WOODBERRY FOREST SUBDIVISION ADDITIONS

APPLICATION NUMBER 5 DATE March 6, 2008

WOODBERRY FOREST SUBDIVISION ADDITIONS

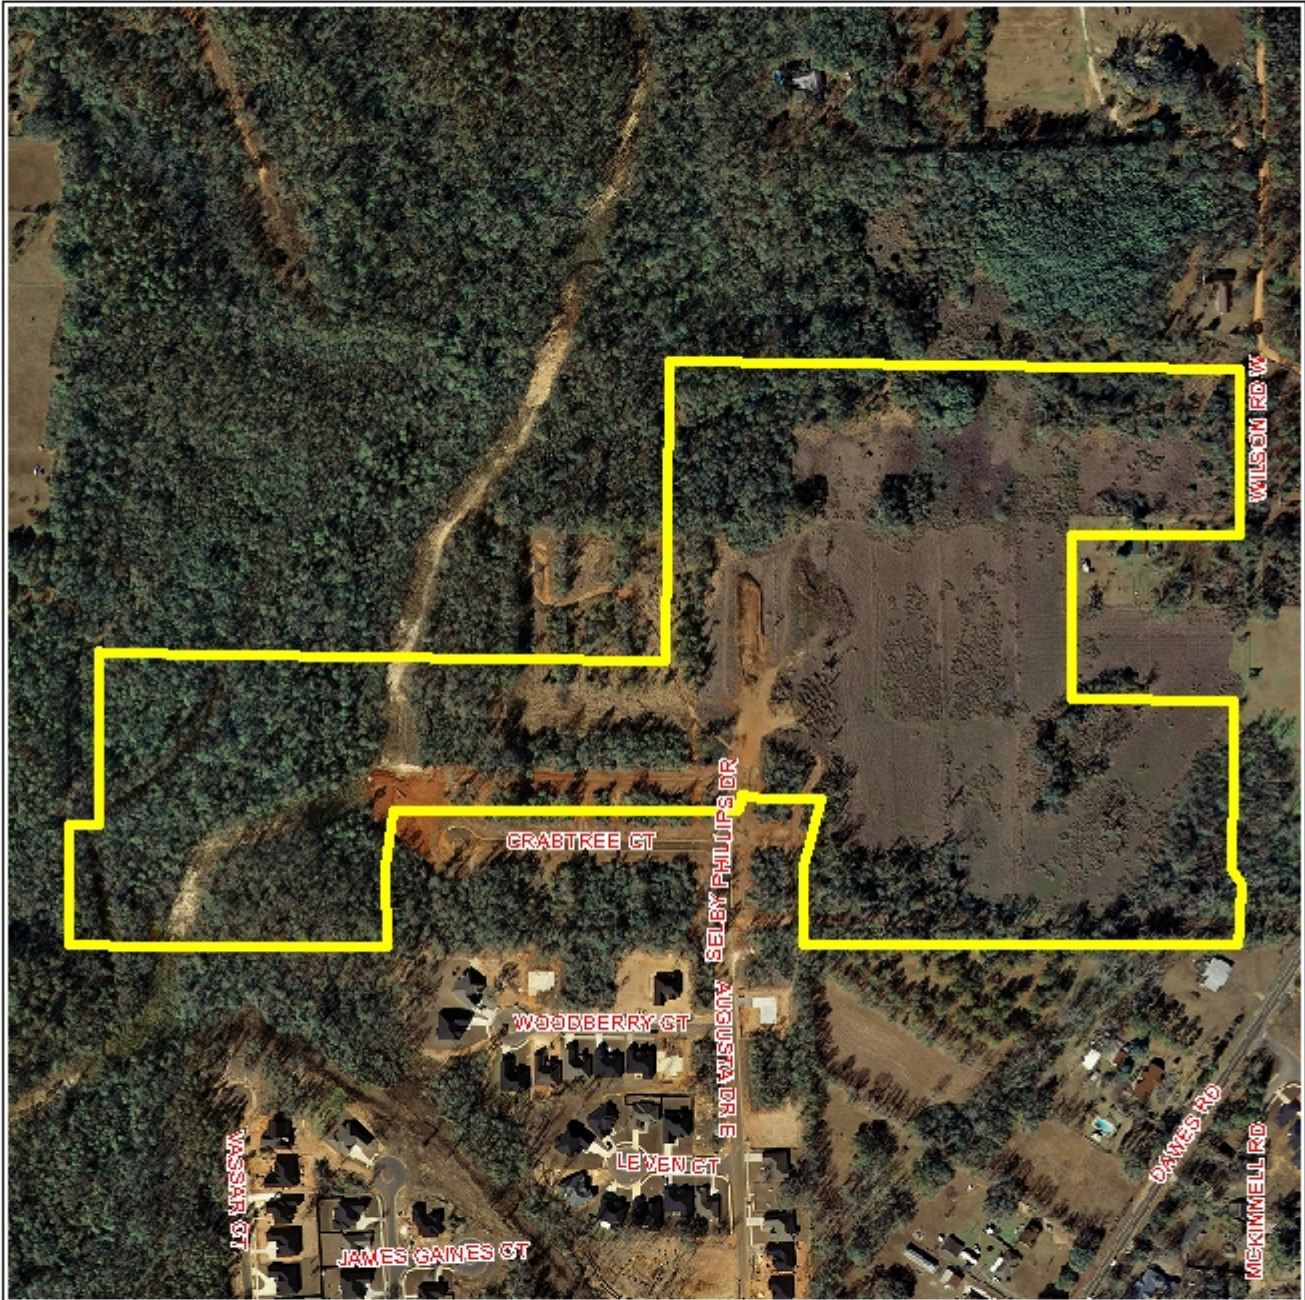
The 25-foot minimum building setback is not shown on the plat, but is required. The setback line should be depicted from all existing and proposed street frontages and labeled.

The plat should be revised to show lot size in square feet, or a table provided on the plat with the same information.

A revised plat was submitted by the applicant, addressing most of the issues previously identified, but not all of the issues were adequately addressed. Specifically, documentation was not provided regarding access to the land-locked parcels to the North of the site (which were documented as being under family ownership). The plat was also not fully revised to depict required dedication for all lots fronting Wilson Road West / Lowry Road (future Dawes Road),

nor was the minimum building setback line depicted from all existing and proposed street frontages.

Due to lack of frontage on paved public streets, the proposed development should be phased. It is recommended that proposed lots 1-16 and 46-78 be prohibited from recording until such time as Grelot Road is built from Dawes Road to Selby Phillips Drive, or until the new Dawes Road is constructed from the existing Dawes Road to Airport Boulevard along the Wilson Road West / Lowry Road alignment. Therefore, only proposed lots 17-45 should be recorded due to lack of access for emergency vehicles, until additional access is provided or available.

It should also be pointed out that the topographic and natural features of the site and the land-locked property to the North indicate that the provision of a street-stub to the East side of the land-locked properties would be advisable, as the land-locked property is bisected by Miller Creek.

- 1) Provision of documentation regarding parcel R022707260000011.001., and its establishment as a future road to serve adjacent land-locked parcels, or provision of a street-stub to the land-locked parcels in the vicinity of the proposed detention area near lots 61 and 62;*

- 2) Placement of a note on the plat stating that development of the site is limited to lots 17-45, and that no additional lots may be recorded until additional access to a public road is provided via construction of Grelot Road from Dawes Road to Selby Phillips Drive, or construction of the new Dawes Road along the Wilson Road West / Lowry Road alignment;*

- 3) Dedication and labeling of right-of-way sufficient to provide 50-feet, as measured from the centerline of Wilson Road West / Lowry Road, including where it abuts proposed lot 78;*

- 4) Depiction and labeling of the 25-foot minimum building setback line from all existing and proposed road frontages, including where lot 78 abuts proposed Grelot Road and Dawes Roads, and where lot 38 abuts proposed Grelot Road and the proposed "future street" on the western boundary of the lot;*

- 5) Placement of a note on the final plat stating that all lots, with the exception of Lot 78, are denied direct access to Wilson Road West / Lowry Road (future Dawes Road) and the proposed Grelot Road, and are otherwise limited to one curb-cut, that Lot 78 is limited to a maximum of three curb-cuts onto Wilson Road West / Lowry Road (future Dawes Road), once it is improved to County standards, and three curb-cuts onto the future Grelot Road, once it is improved to County standards, and that the size, design and location of all curb-cuts are to be approved by the Mobile County Engineering Department;*

- 9) *Labeling of all common areas and detention common areas, and placement of a note on the Final Plat stating that maintenance of the common areas, including detention areas and any other common areas, is the responsibility of the subdivision's property owners;*

- 12) *The labeling of all lots with their size in square feet.*
